ADDENDA AND MODIFICATIONS

ADDENDUM NUMBER: 1 **DATE:** July 21, 2005

PROJECT: WORKFORCE SERVICES
DFCM PROJECT NO. 04045920
Architect Project No. 04139

ISSUED BY: ARCHITECTURAL NEXUS, INC.
Bruce Haslem, Architect

M102	Addenda Logan, Utah Workforce Services Upper Floor Mechanical Plan 7/21/05	SPECTRUM ENGINEERS 40 Cache Valley Blvd., Suite 2 Logan, Utah 84341 435-735-3456 FAX 435-753-3469 www.spdesign.com
2

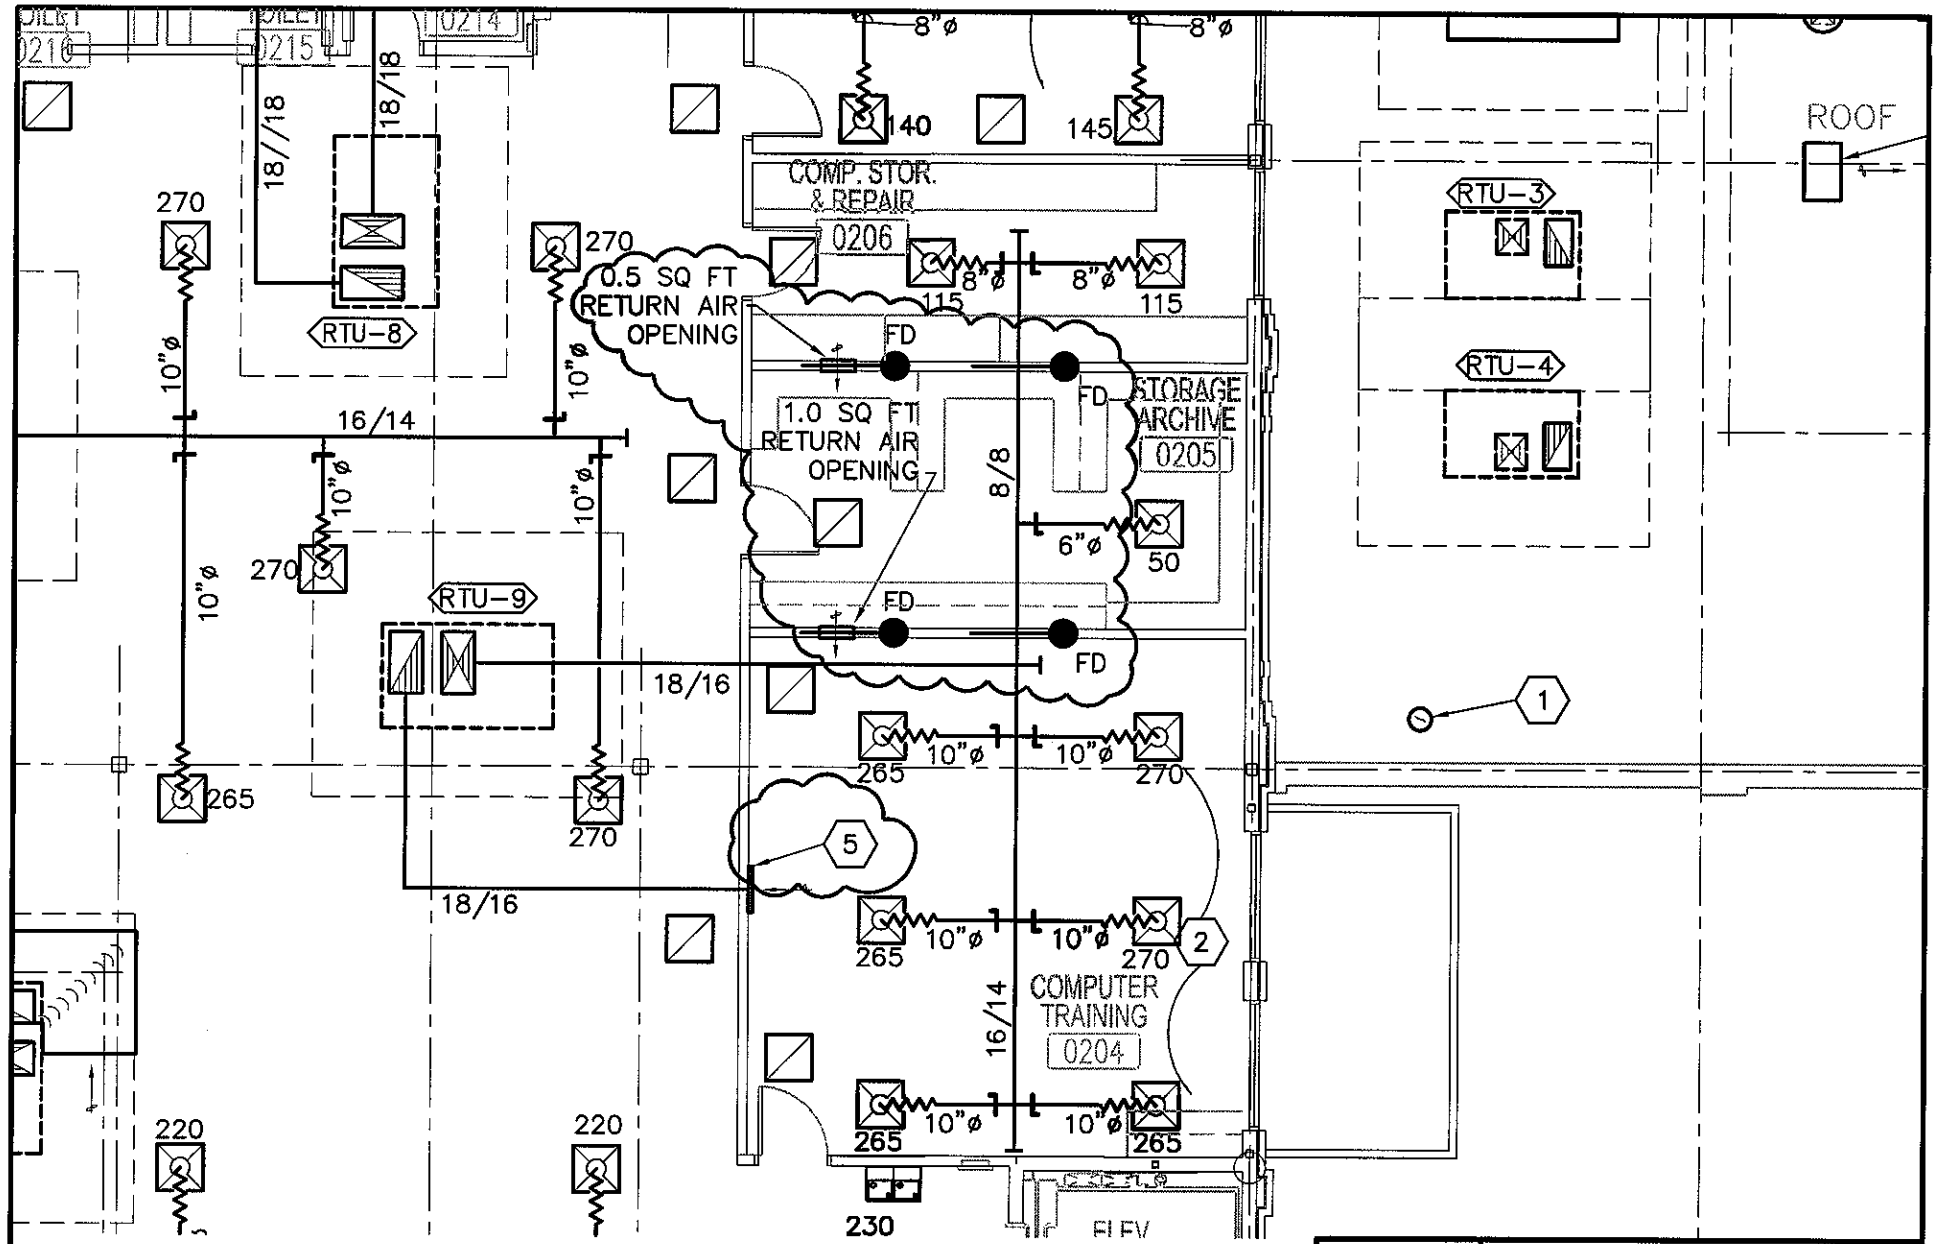
2. Add fire damper to rooms 205 and 206. Change keyed note 3 to 5. See attached 2/MH102.

P101

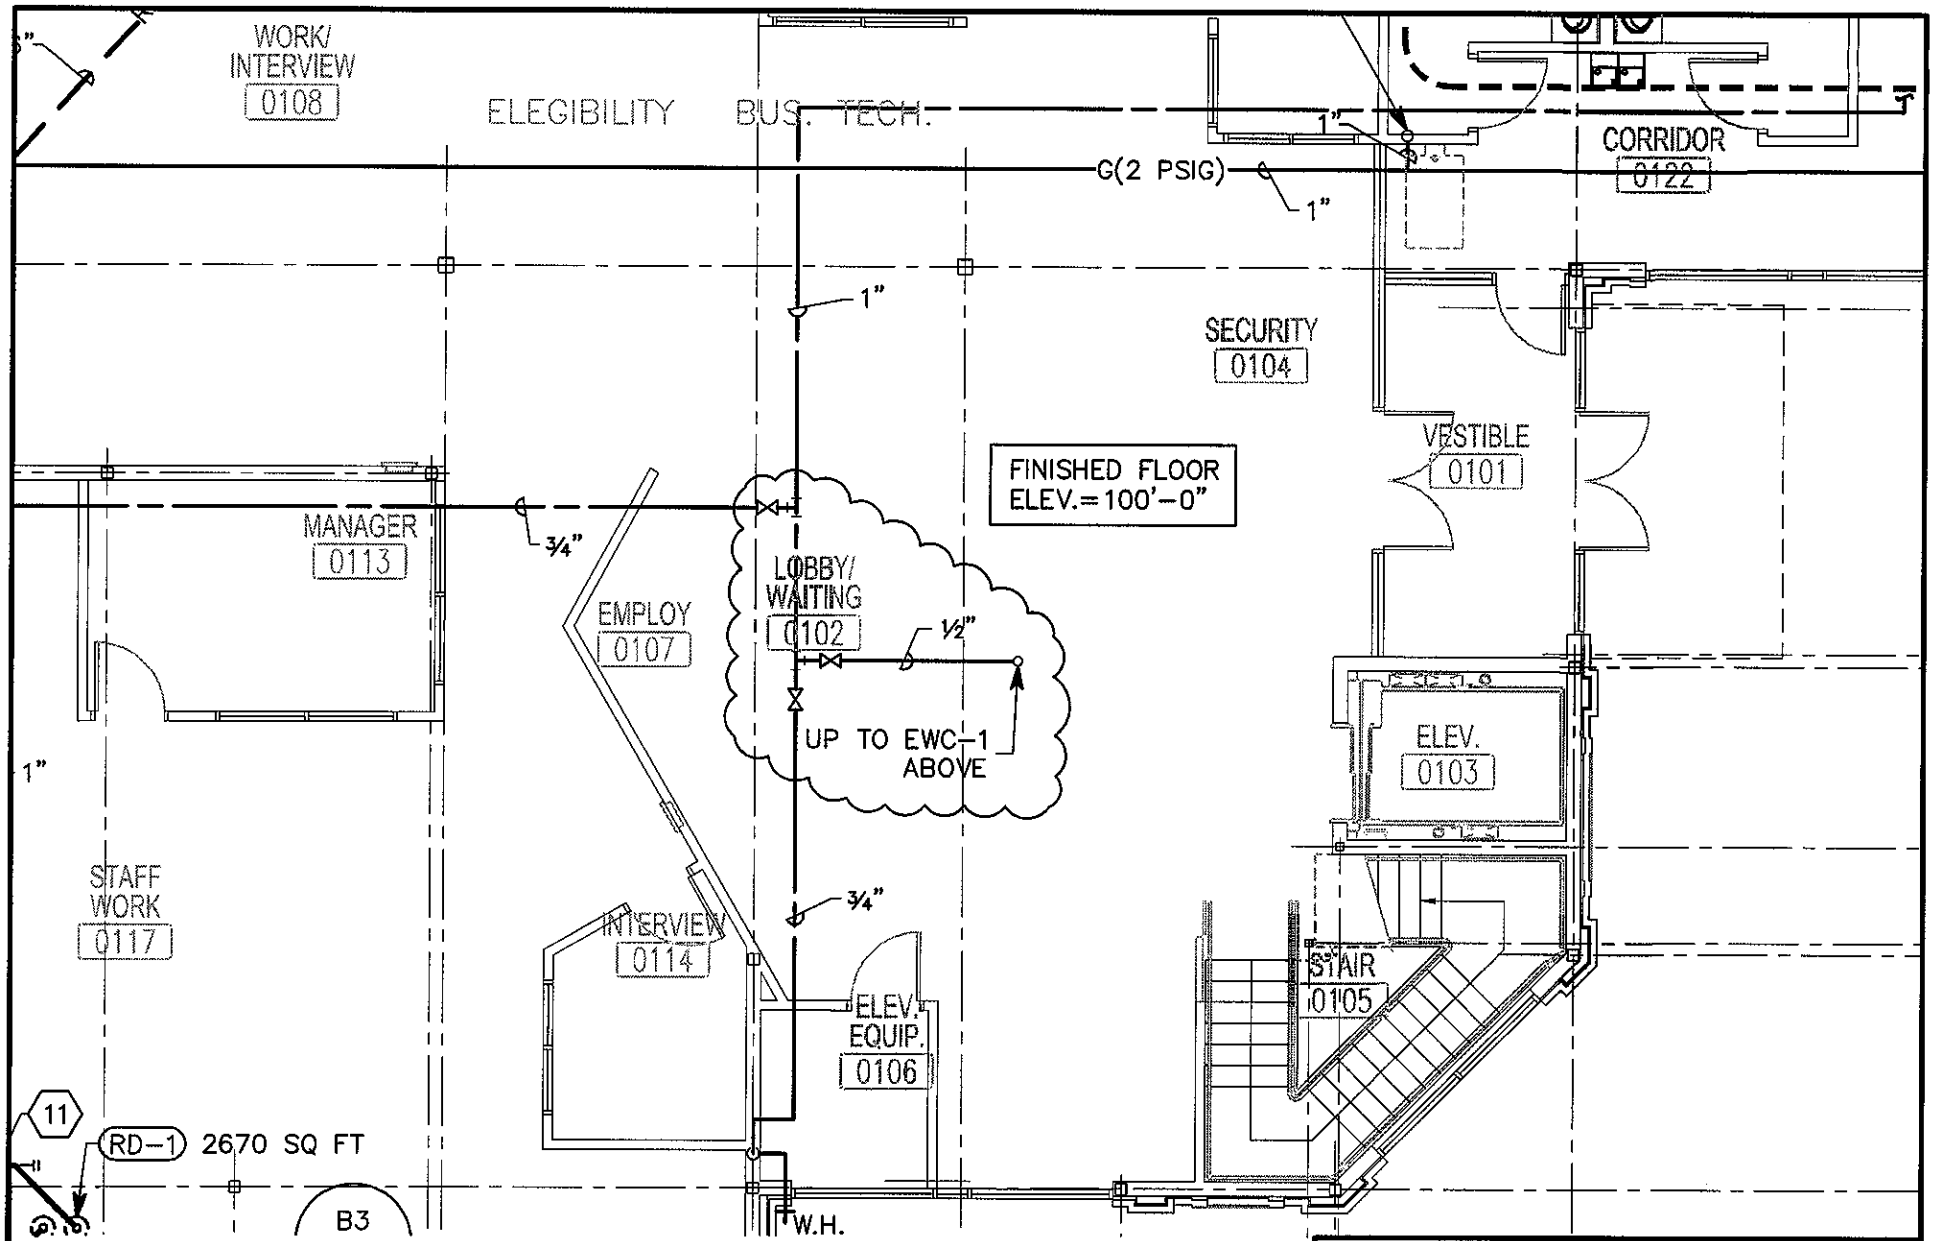
5. Extend ½" CW line off of ¾" line serving wall hydrant and rise up to water cooler on second level (see attached.)

E201

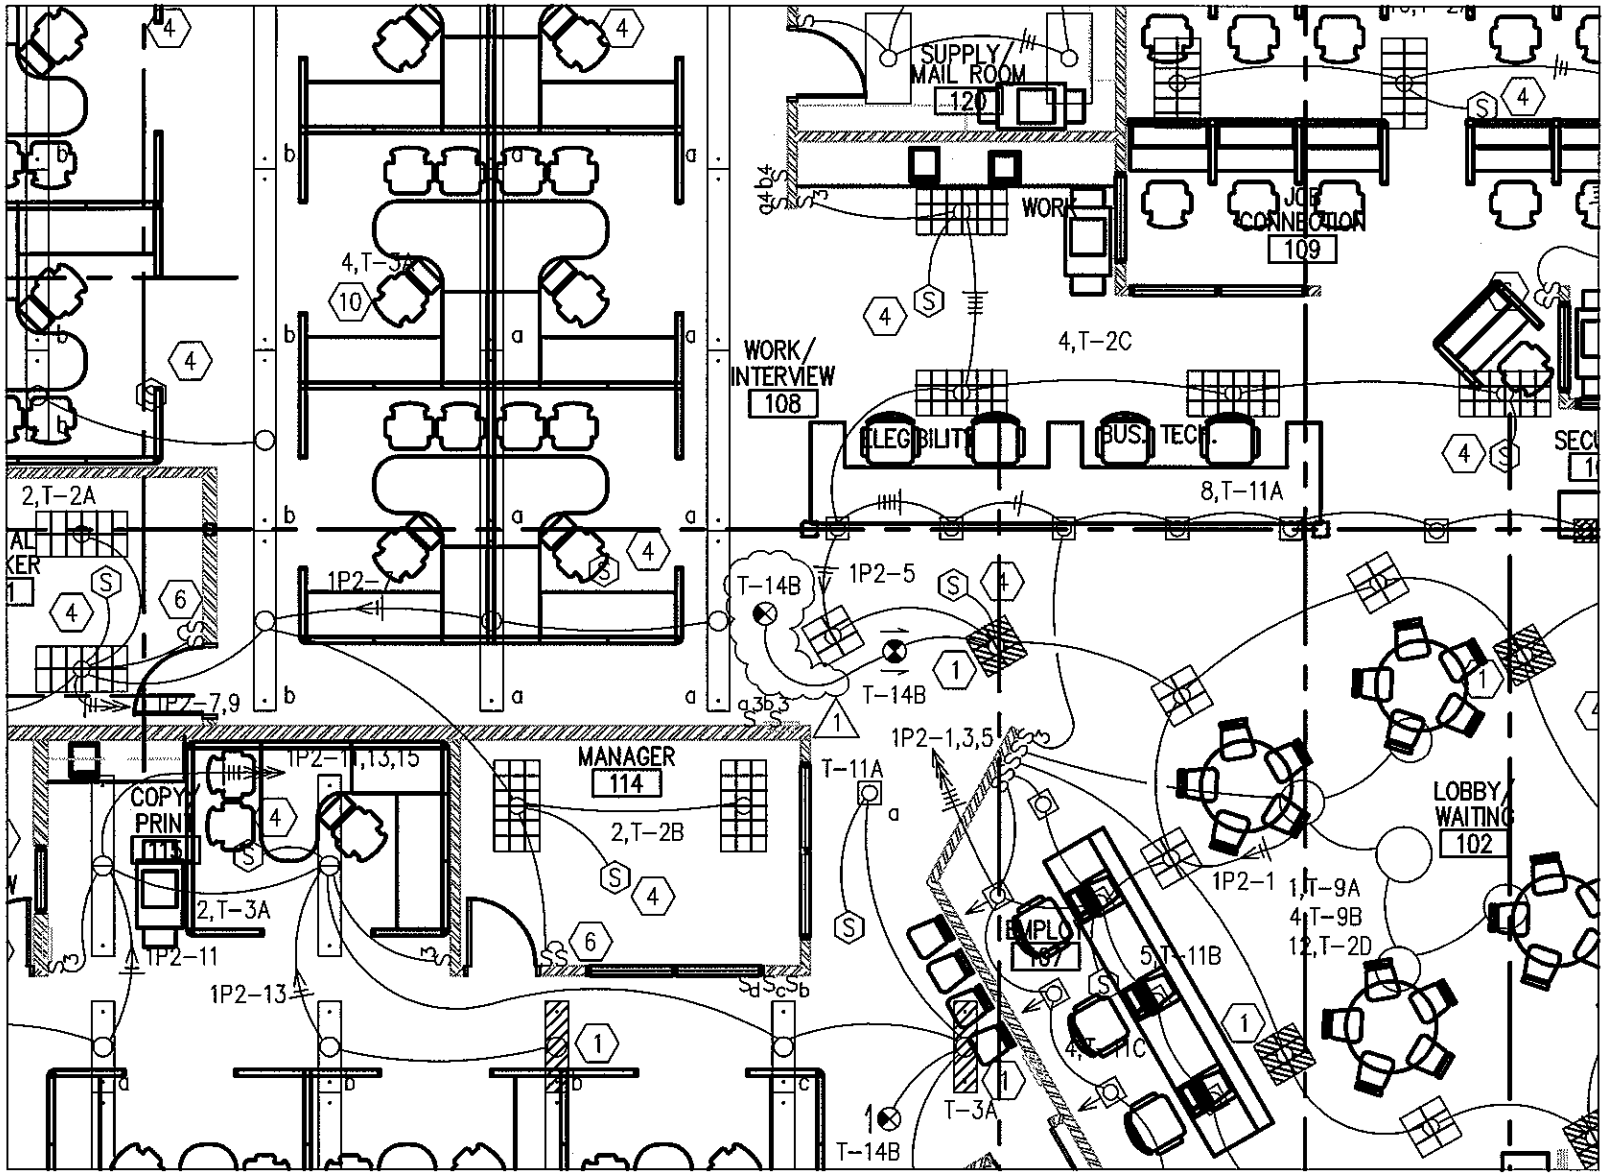
I. SHEET E201: Add T-14B exit sign at intersection of grid C.25 and 4.3. See attached drawing.
